In response the EC's questions about the proposed use of a natural pond for the disposal of domestic gray water:

47 A/6

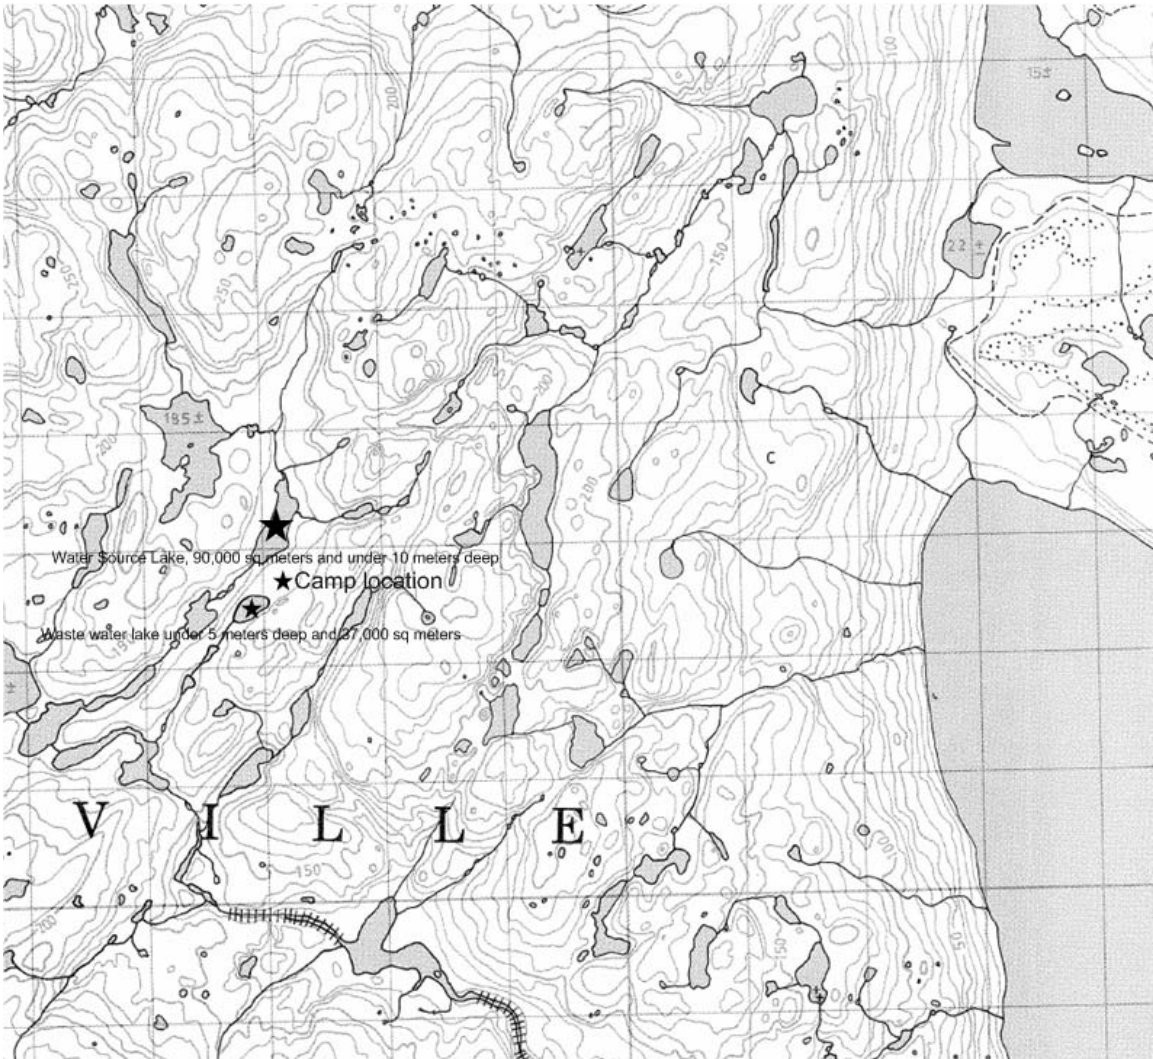
- Will the pond's free-board prevent the release of its contents into surface drainage areas?
 - o We do not know the length of the freeboard of the pond in question, although we believe that given the relatively small amount of water which will be added, that it should not be a problem. If, upon arrival at the camp, it seems that the freeboard will not prevent the release of its content into surface drainage areas, a different pond will be selected.
- Is the pond frequented by fish?
 - o To our knowledge, based on historical environmental reports of the area, there are no fish in this pond. If fish are found during camp set-up, then a different pond will be selected.
- The ponds dimensions:
 - o Source lake: ~90,000 sq. meters, depth <10m
 - o Waste lake: ~37,000 sq. meters, depth <5m
